Title		
Size	Number	Revision
A		
Date:	11/29/2017	Sheet of
File:	C:\Users\...\Audio.SchDoc	Drawn By:

Title		
Size	Number	Revision
A		
Date:	11/29/2017	Sheet of
File:	C:\Users\...IR.SchDoc	Drawn By:

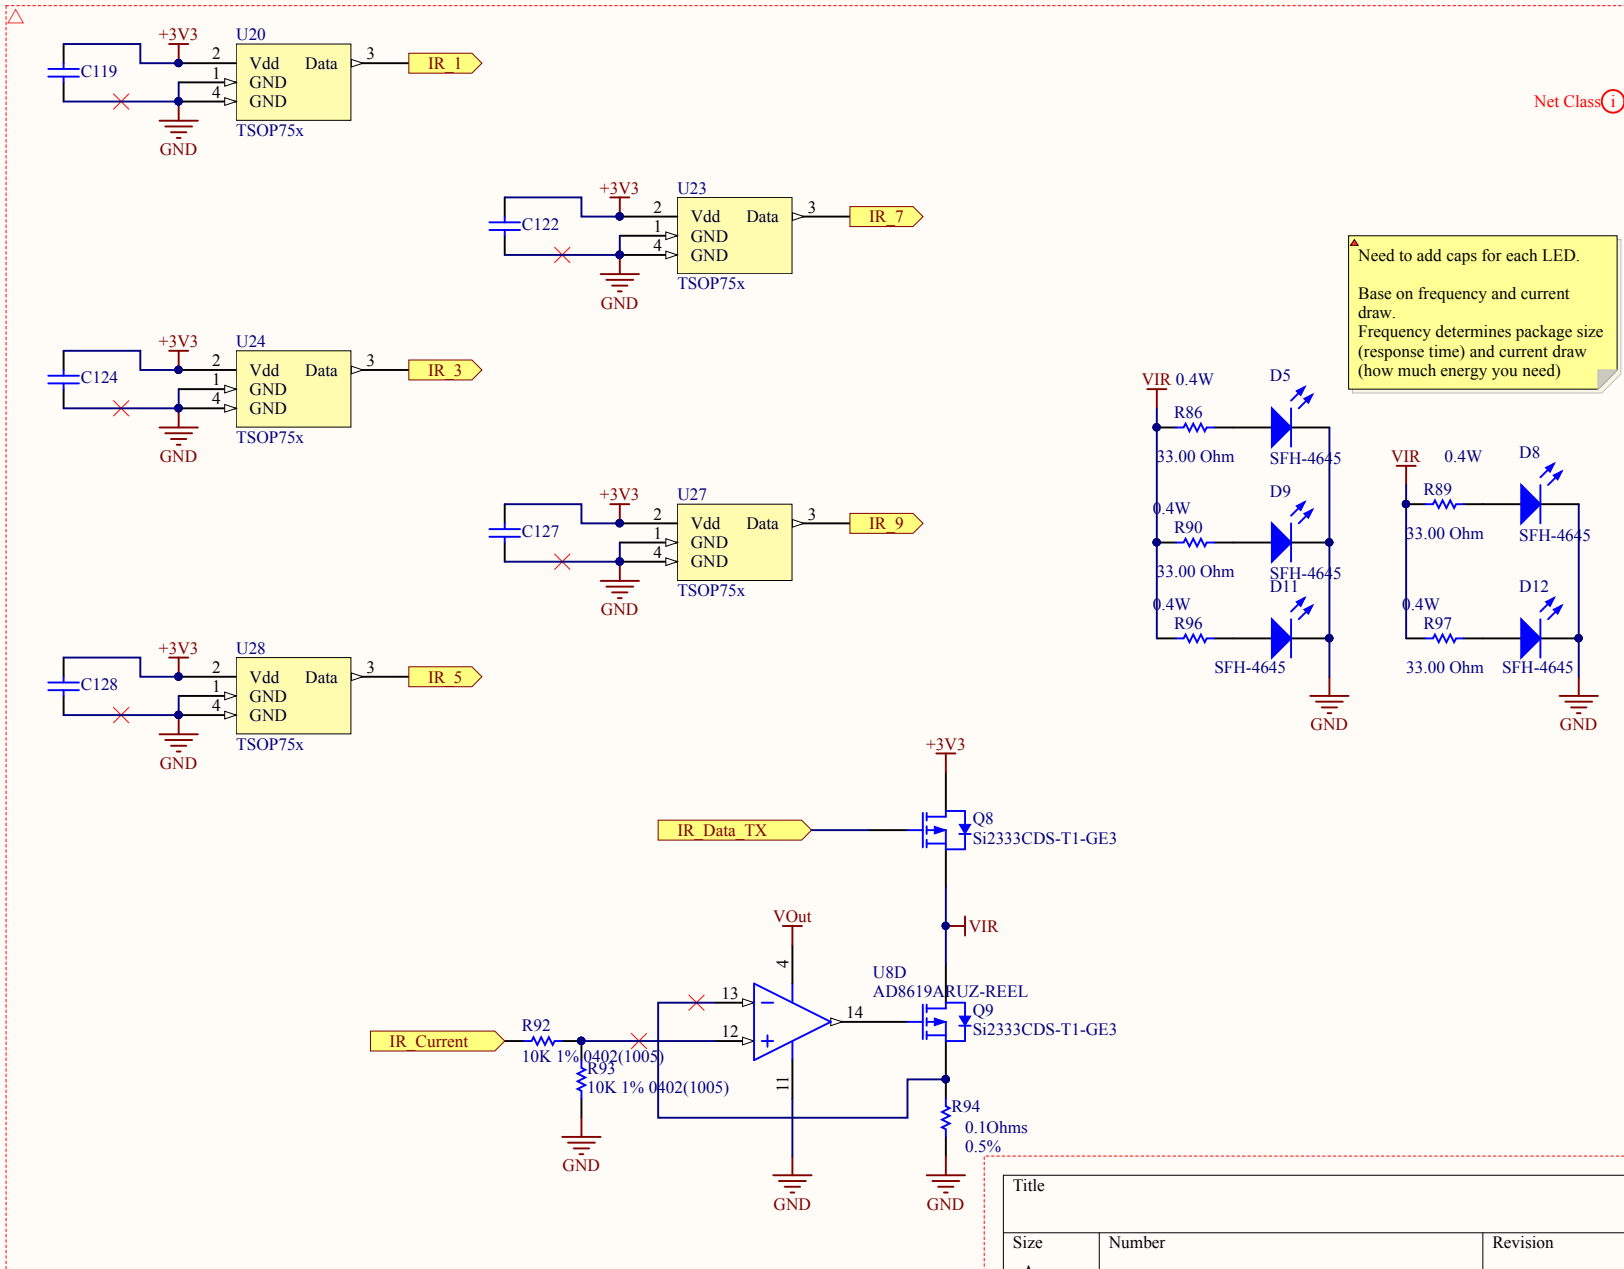
Need to add caps for each LED.  
Base on frequency and current draw.  
Frequency determines package size (response time) and current draw (how much energy you need)
